**SUBMISSION FOR APPLICATION No. SSD5752**

**Please find below letter that OBJECTS to the current Development Application SSD5752.**

See the diagram of the back of the ICC below, which will be approximately the same height as the Goldsbrough.

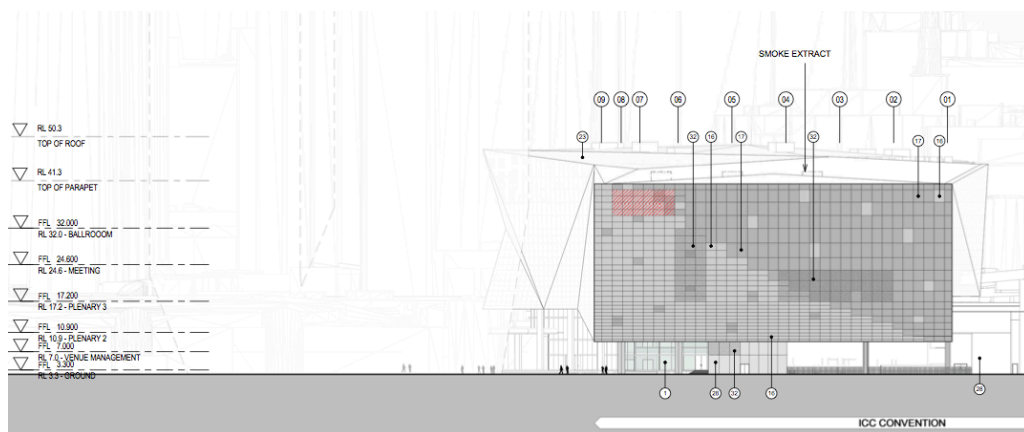
We object to the height of the proposed new ICC which is planned to reach nearly to the top of the Goldsbrough's current height. In DA plans the proposed height RL 50.3 will block the entire view to Darling Harbour and the city from the Goldsbrough's eastern facing apartments. As a heritage building the current views for the eastern facing apartments are a significant part of the iconic building attraction. Removal of these views will reduce property prices and increases the risk the current building becomes less attractive for property owners and will turn into a vacant ghetto which will be to the detriment of the area.

In place of the current city skyline and Darling Harbour view there will be a flat blank metallic wall in its place, which is the rear of the proposed ICC building. While the front of the ICC building is designed with glass and is broken up in angles, but the Goldsbrough will be facing an ugly flat back wall made of aluminum and mainly Grey.

See Diagram below for view of the Western face of the ICC facing the Goldsbrough. Note the scale of this wall in relation to the people in the picture.

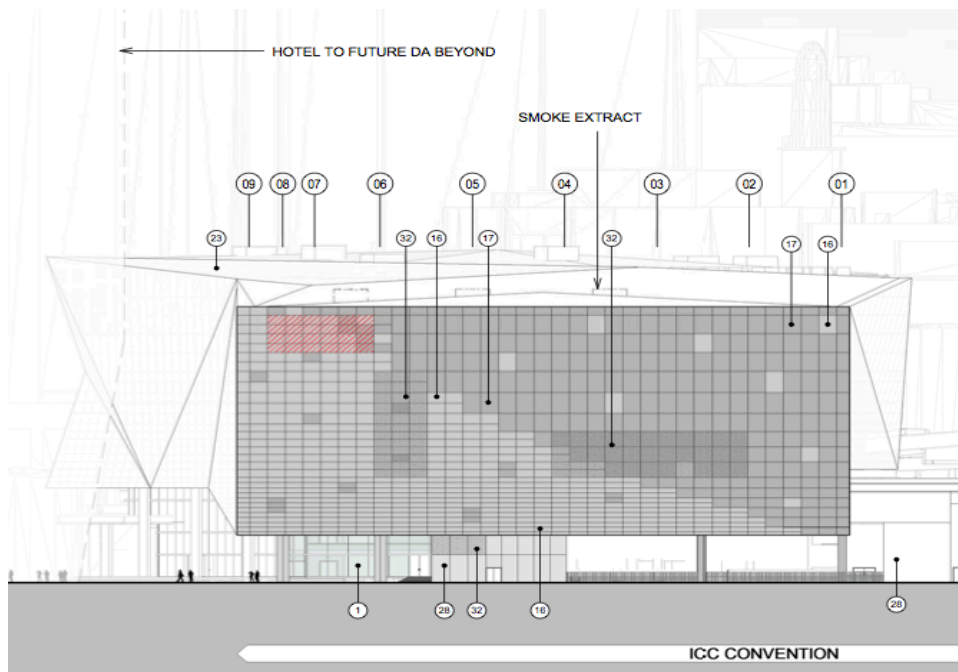
As the height of the proposed ICC is nearly the current height of the Goldsbrough, any outlook from the Goldsbrough to Darling Harbour will be dominated by the Western (rear) face of the ICC. All the publicity shots show the view of the East face yet all the Goldsbrough will see is the ugly utilitarian Western face.

If the view from the Goldsbrough is to be dominated by the ICC then at least some regard should be paid to the fact and the Western face of the ICC modified to be more aesthetically appealing. The western face could be architecturally articulated and made of materials that don't look like a metal barricade.
